September 8, 2015

Re: City of Santa Monica Comments to the Southern California Metroplex Draft Environmental Assessment

Appendix 1
Proposed SMO Alternatives Shown in EA Exhibit 3-8

SMO PROPOSED DEPARTURES

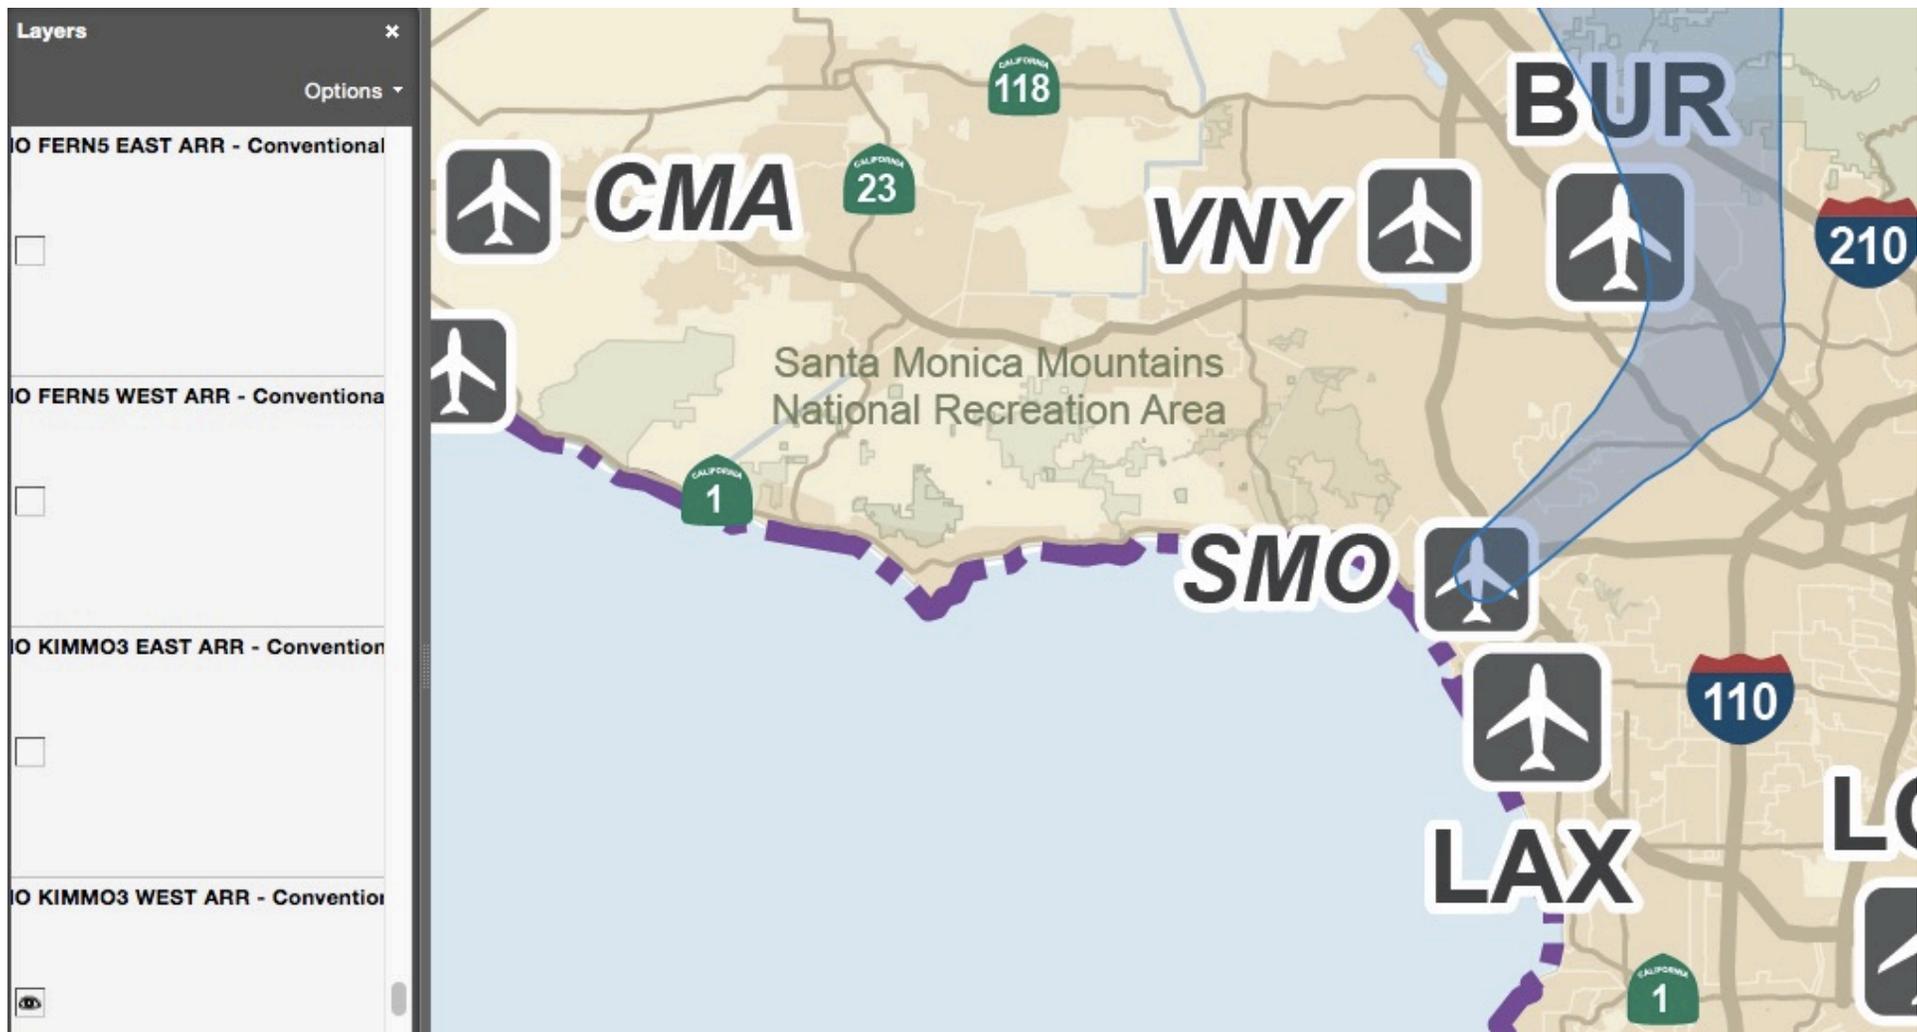
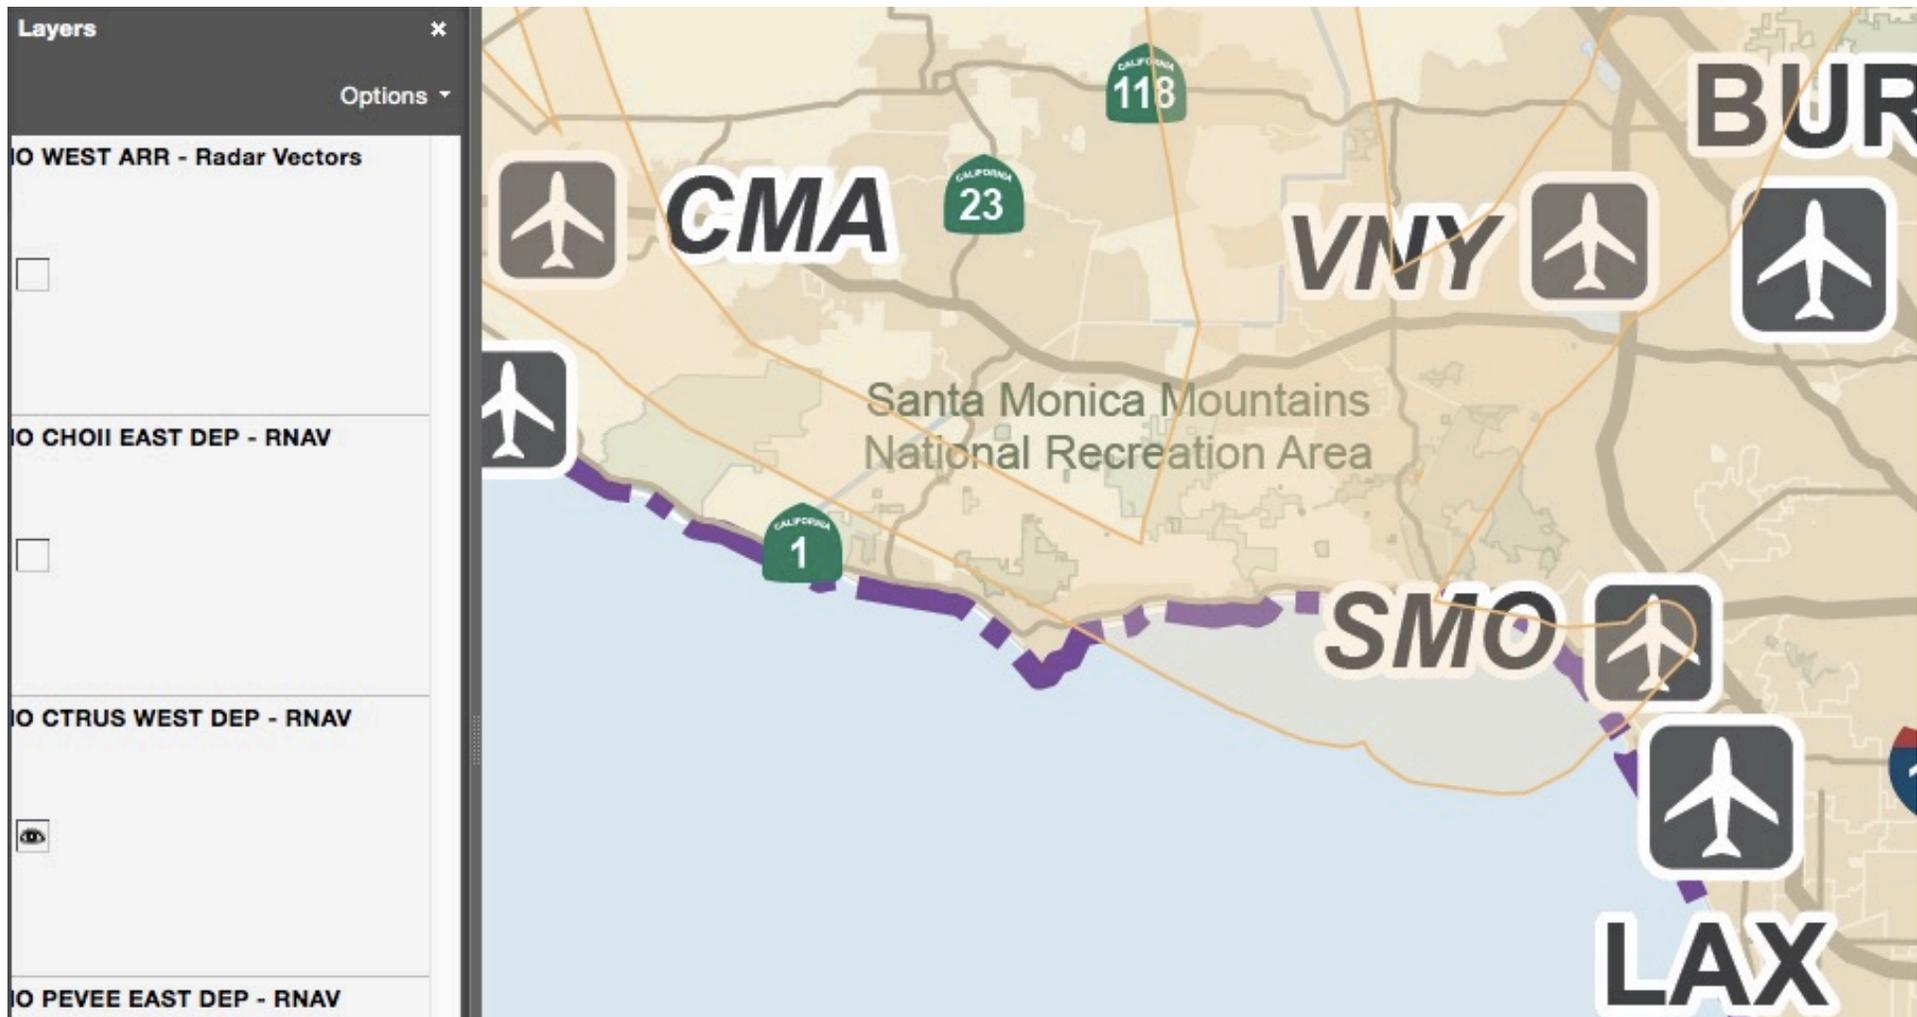
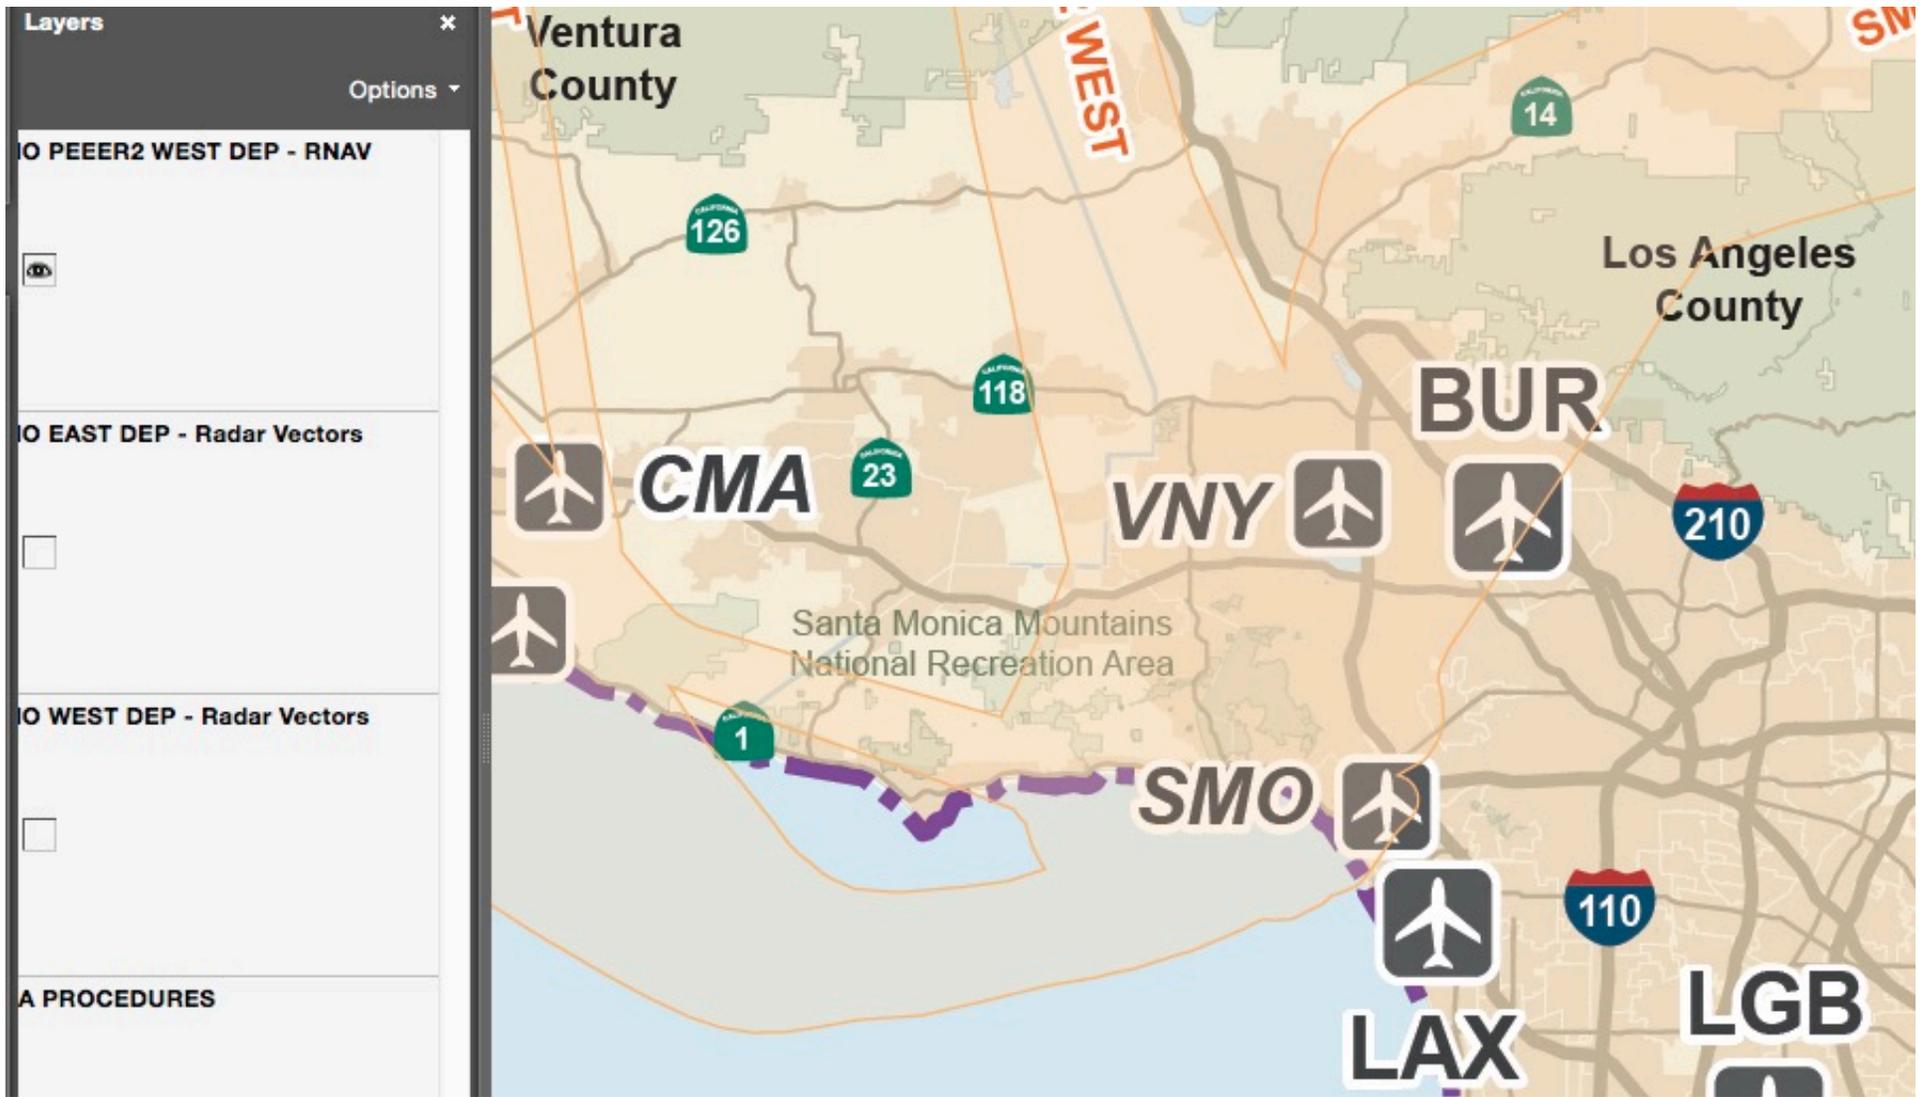
Exhibit 3-8 shows, for readers that are proficient in using Adobe Acrobat layers (and is blank for most users), that there are 15 procedures that affect SMO. Appendix 1 shows the 15 procedures proposed for SMO (these are screen shots from Exhibit 3-8). There is no explanation for the discrepancy between Tables 3-2, 3-3 and Exhibit 3-8 where Exhibit 3-8 shows 15 procedures for SMO, but Tables 3-2 and 3-3 only list 12 such procedures. And, the proposed RNP procedures listed in Table 3-3 are not shown, or incorrectly labeled in Exhibit 3-8.

The route descriptions provided in Exhibit 3-8 (screenshot copied directly in Appendix 1) are entirely inadequate for purposes of the EA. The scale of the map has insufficient resolution to identify the locations of any of the procedures proposed for any of the airports. A reader cannot determine if a proposed route affects his or her home or not. This exhibit does not inform the reader and it is the only place where the reader has any hope of figuring out what the FAA is actually proposing.

The route descriptions shown in Exhibit 3-8 (Appendix 1) are shown as very wide corridors and not shown as the SID, STAR, or RNP route that would be published as a result of this project. While it is true that a SID or a STAR will have more dispersion than an RNP route, the broad overly wide corridors shown in Exhibit 3-8 make it impossible for the reader to know where the proposed route actually is located. More importantly, since this is the only place in the EA where the routes are mapped and they are shown as such broad areas, the EA could conceivably be used now or in the future to provide environmental clearance for any route that falls within these broad areas.
